# Work Order ID 119543

Item Name: Fwd Crosstube - High

DRAWING NO. D212-664-141	TITLE XTUBE ASSY (205/212/412 HI FWD)	REV. D	DART AEROSPACE LTD ENGINEERING ORDER		D.E.O. NO. D212-664-141-D-1	SHEET NO. SHEET 1 OF 2	SCALE NTS
DRAWN	CHECKED	MFG. APPR.	APPROVED	DE APPR.			
DATE 11.04.07	DATE 11.07.11	DATE 11.04.12	DATE 11/04/12	DATE 11.04.12

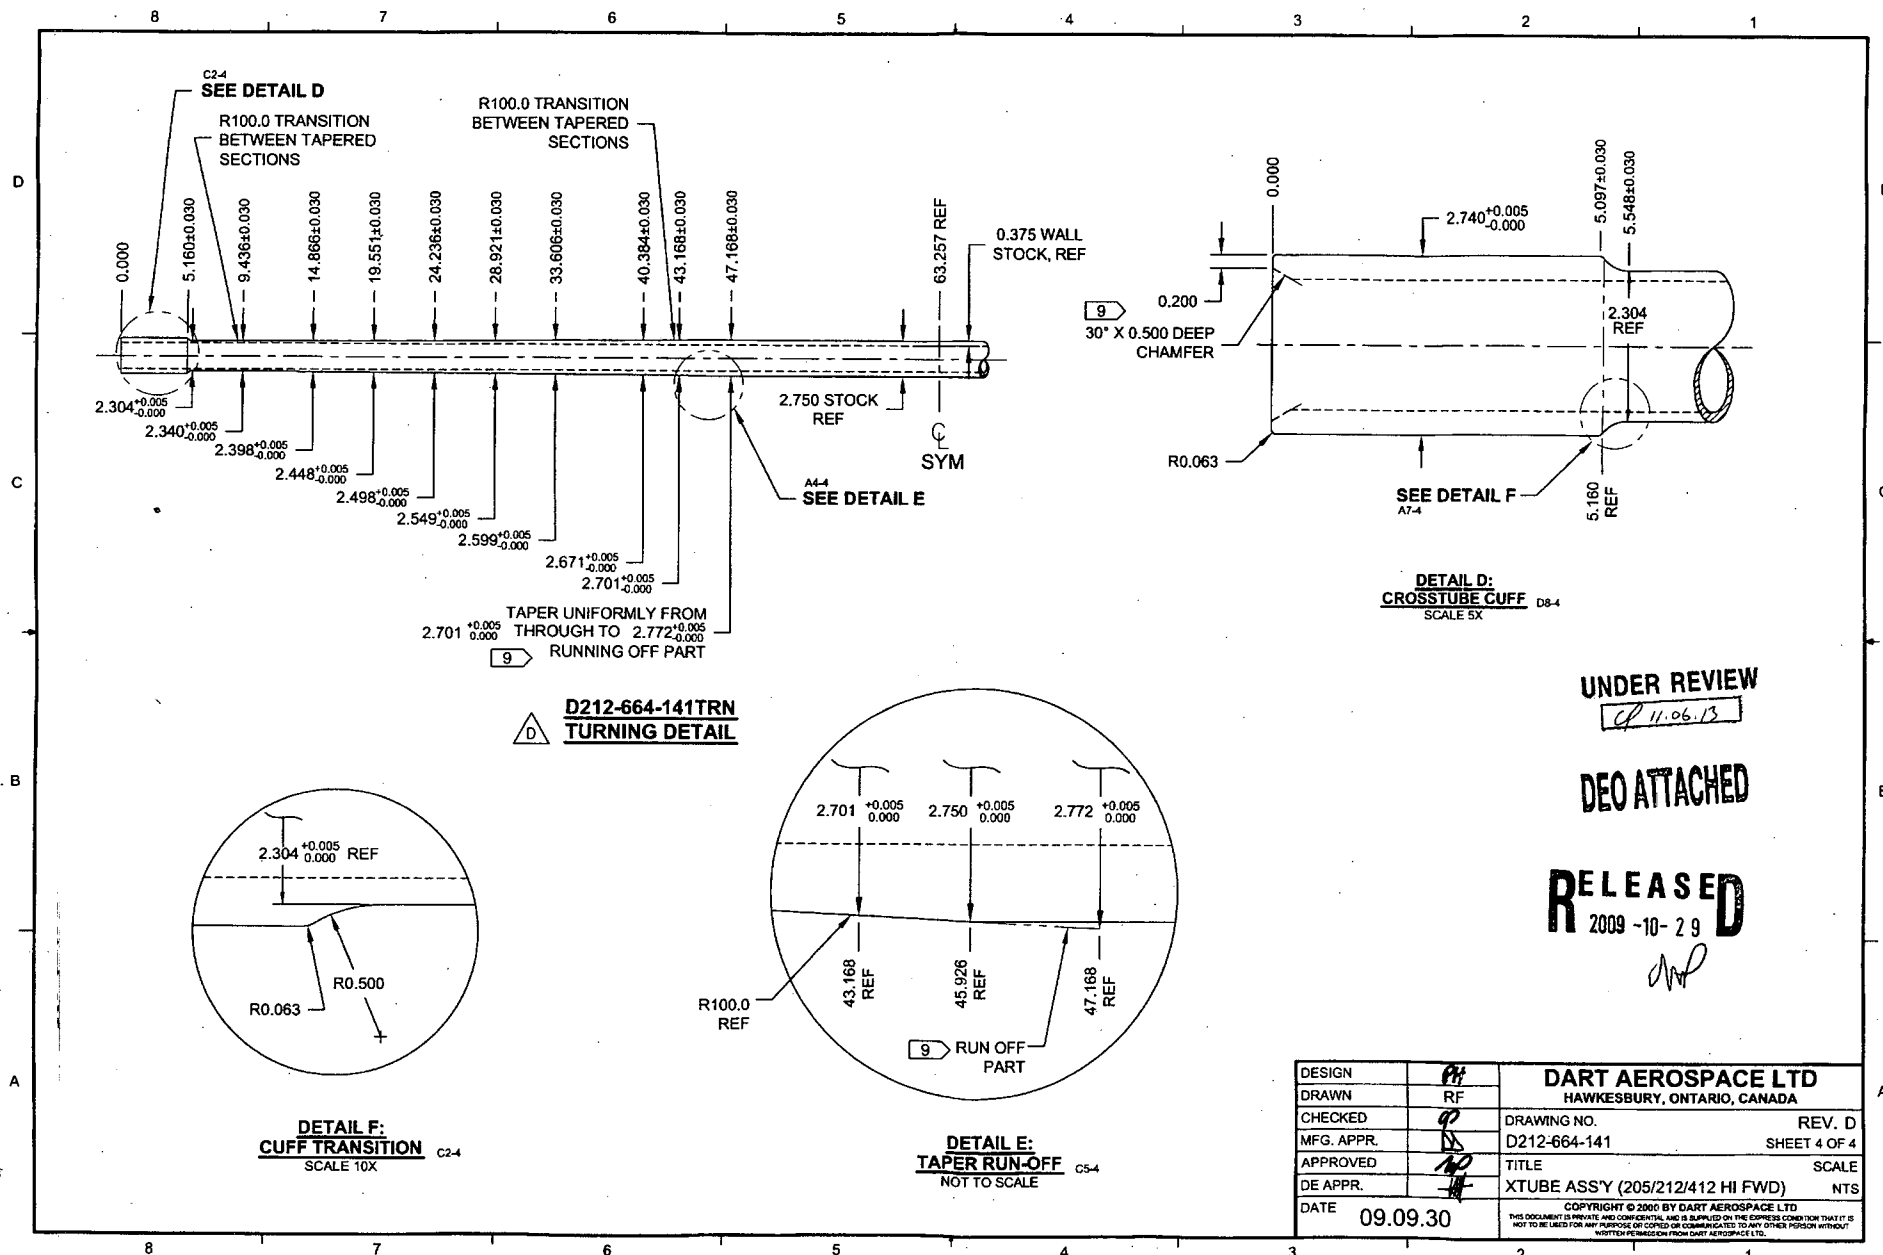
**PURPOSE:**

ADD AN INSPECTION WINDOW TO UNDERSIDE OF CROSSTUBE.

**CHANGE:**

NOTES 2 OF SHEET 1 IS AMENDED AS FOLLOWS:

- 2) FINISH: CHEMICAL CONVERSION COAT PER DART QSI 005 4.1  
PRIME INSIDE AND OUTSIDE PER DART QSI 005 4.2  
MASK UNDERSIDE OF CROSSTUBE AS SHOWN (HATCHED AREA) AND  
PAINT OUTSIDE PER DART QSI 005 4.2  
REMOVE MASKING AND APPLY CLEAR COAT

**D212-664-141/-141B  
ASSEMBLY DETAIL**

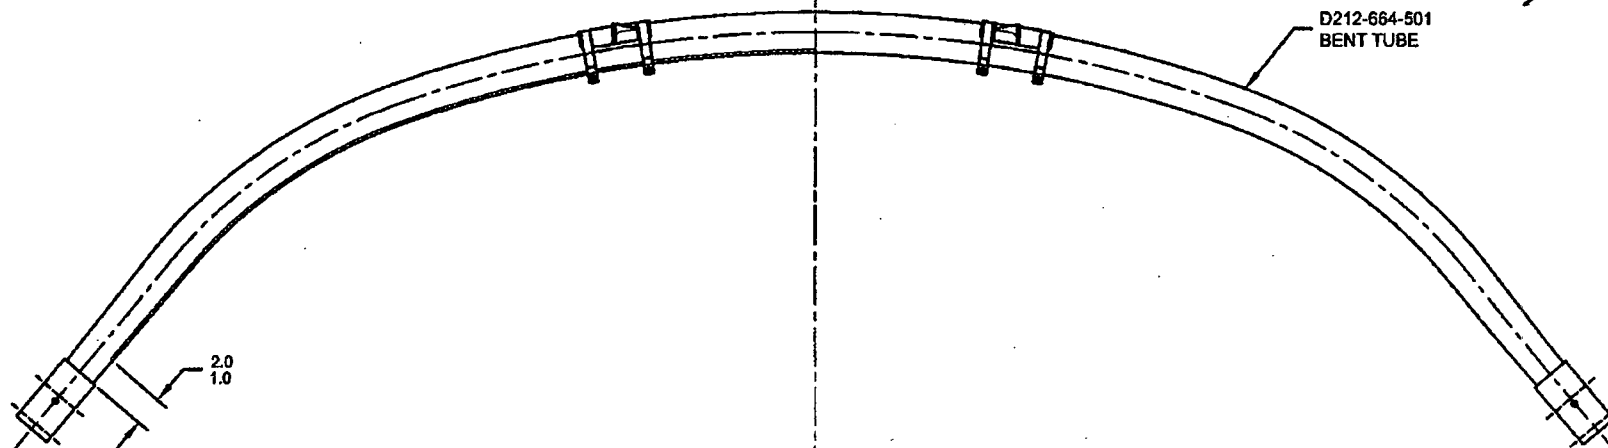
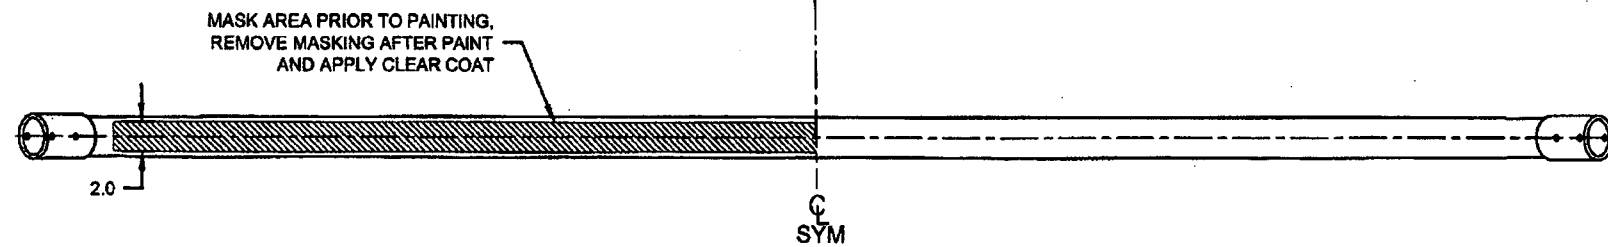
REPLACE MAGNOBOND WITH PROSEAL.

**CHANGE:**

NOTE 12 & 15, SHEET 1 IS AMENDED AS FOLLOWS:

- 12) TO INSTALL D2893-1 SUPPORT: ABRASE MATING SURFACE OF SUPPORT AND CROSSTUBE WITH 180-GRIT SANDPAPER AND REMOVE RESIDUE WITH MEK (OR EQUIVALENT). APPLY A 0.04" TO 0.07" THICK LAYER OF PROSEAL 890 CLASS B-2 (OR AMS-S-8802 CLASS B-2) SEALANT TO MATING SURFACE OF SUPPORT.
- 15) TORQUE CLAMPS 80 TO 100 IN-LB. ENSURE AT LEAST 1.5 THREADS SHOWING IN SAFETY AND THAT NUT HAS NOT BOTTOMED-OUT AFTER TORQUING. **PRIOR TO PACKAGING, RE-CHECK TORQUE ON CLAMPS AFTER PROSEAL 890 SEALANT HAS CURED FOR 72 HOURS.**
